CORRIGENDA

ISSUE 1

Page 43. Fig. 6, R65 value is 1k; R71 & R72

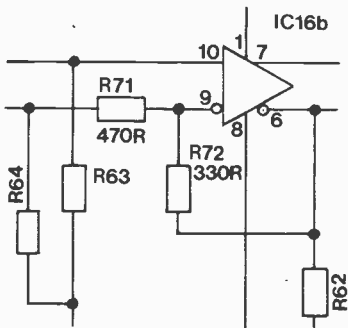
have been added thus:—
